Development Review Comments

PAM2024-00151

2101 Gaither Road

PRE-APPLICATION SITE PLAN

HYDRAULIC PLANNING ANALYSIS
PARK PLAZA

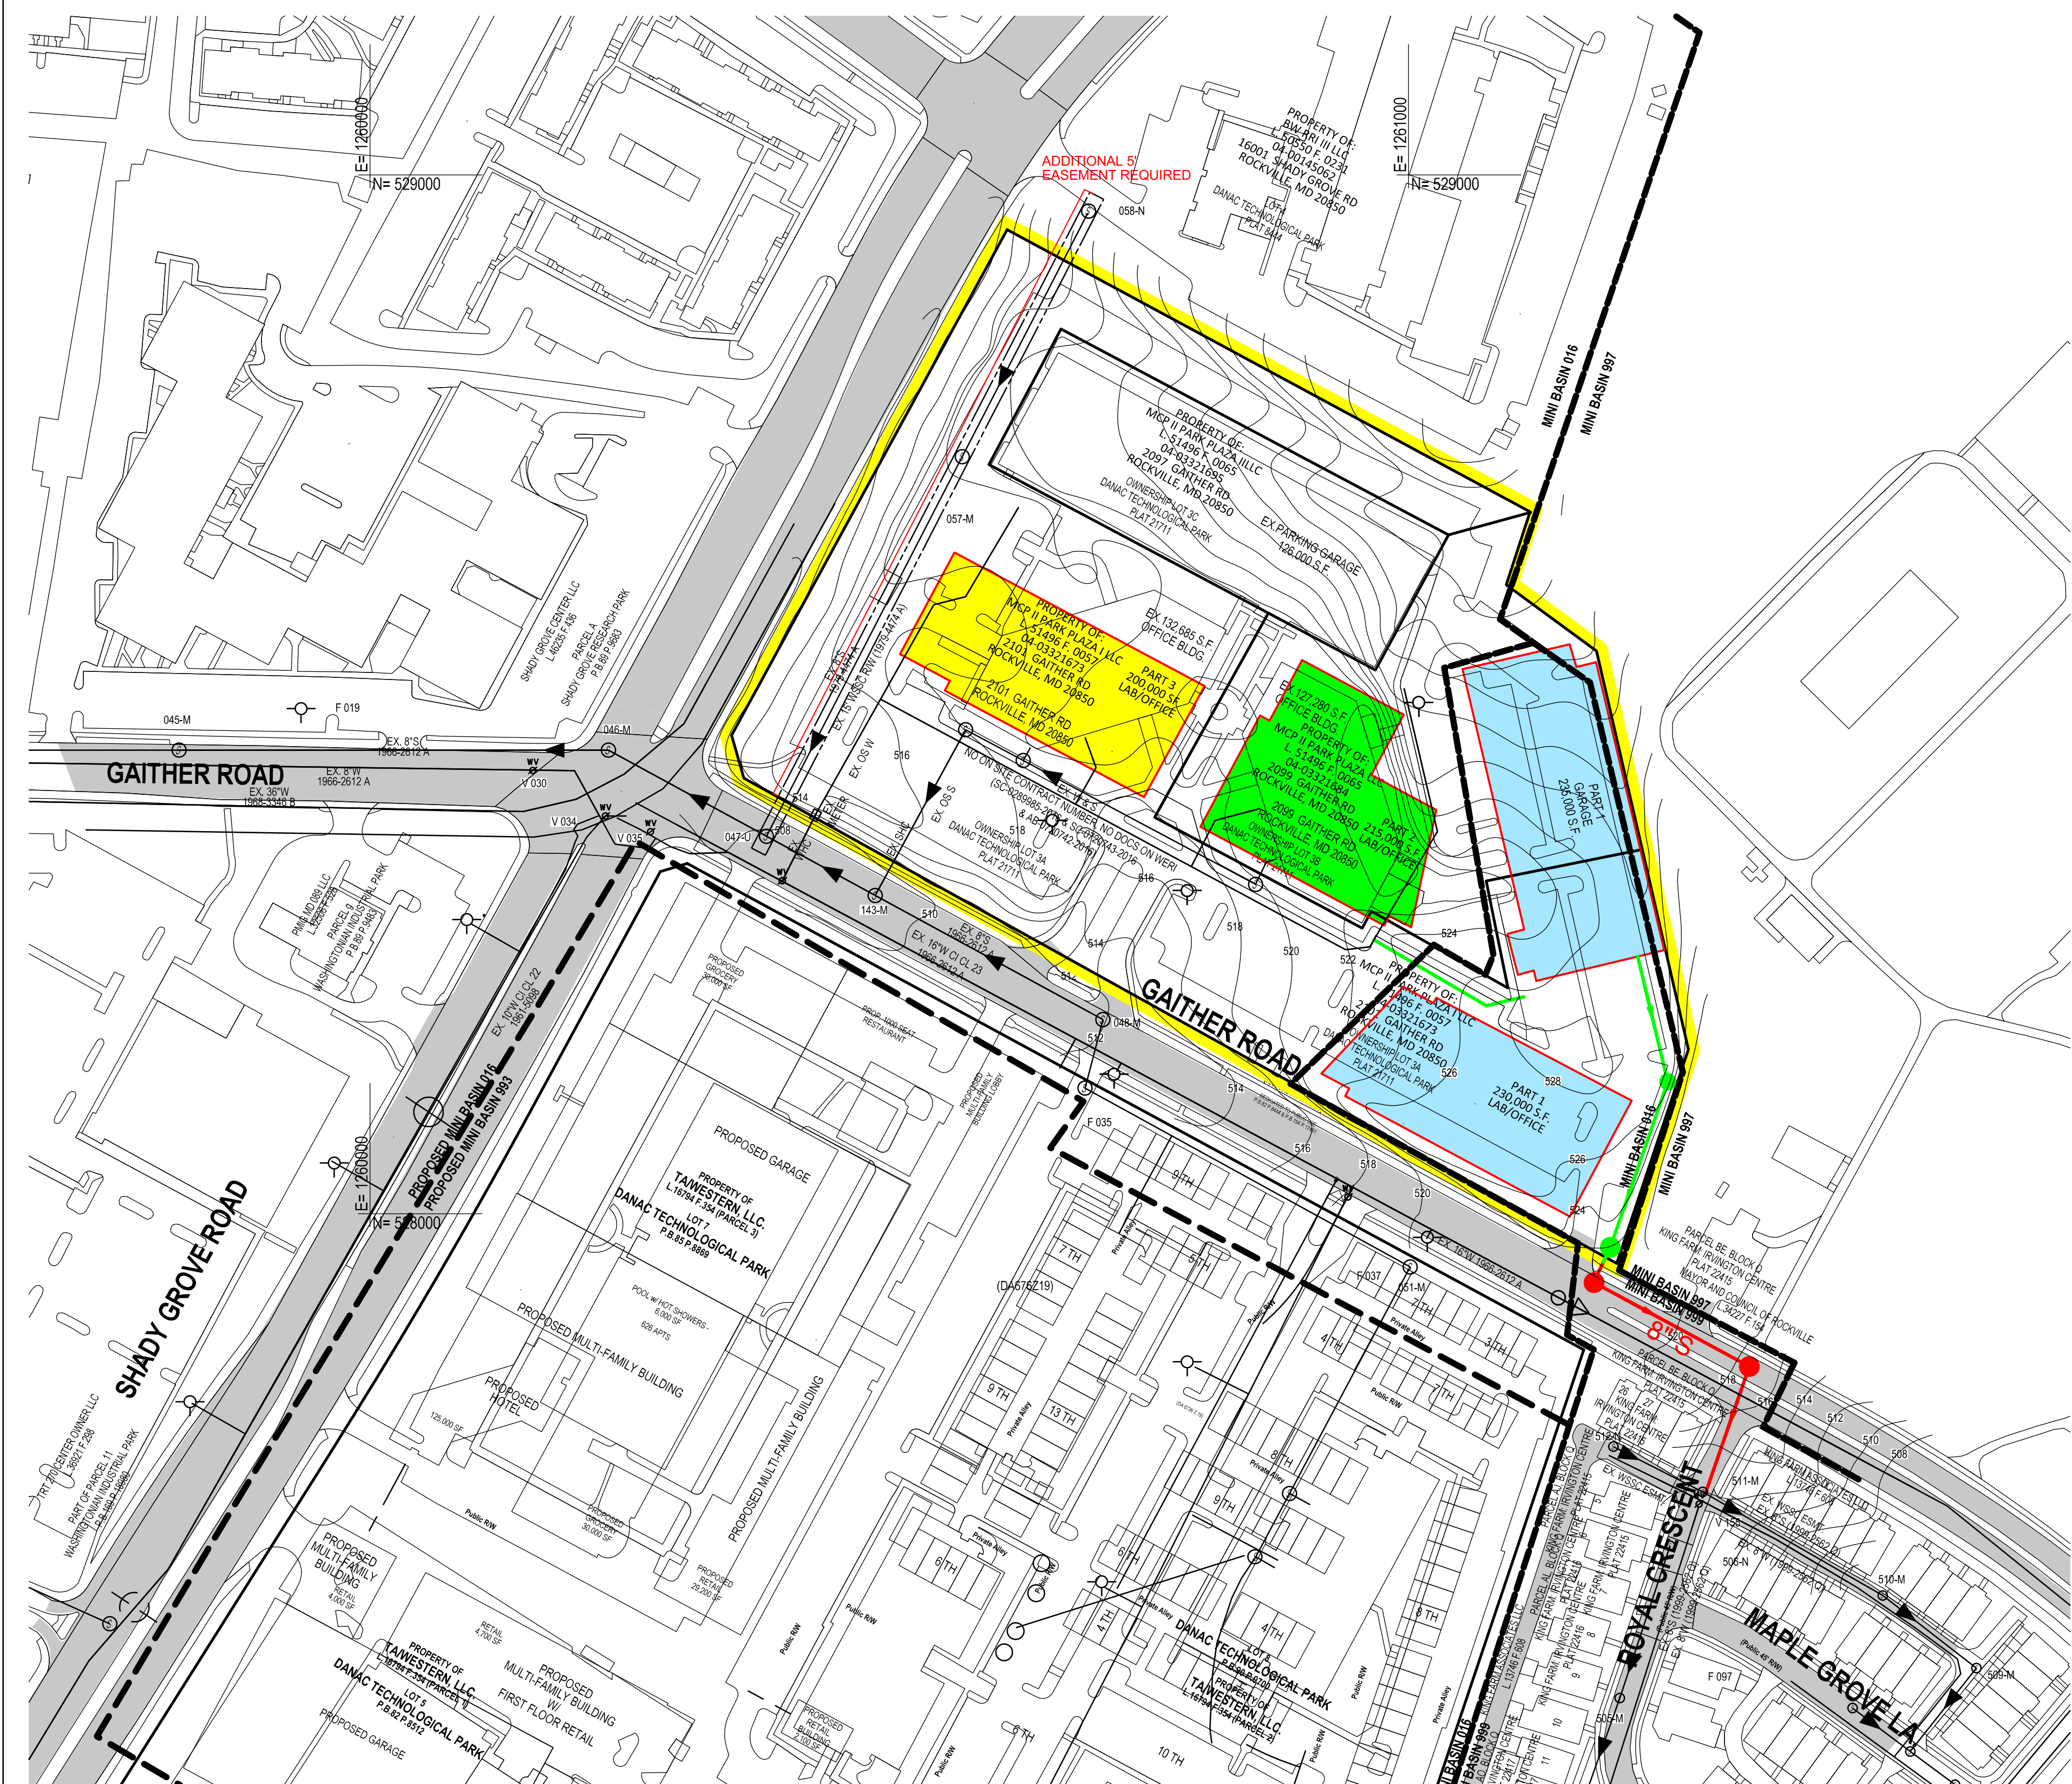
Additional easement is required to adequately maintain an existing main. The additional easement must be provided at no cost to WSSC. Provide five feet of additional easement width alongside the existing 15-foot easement that crosses this property as shown on the attached sketch.
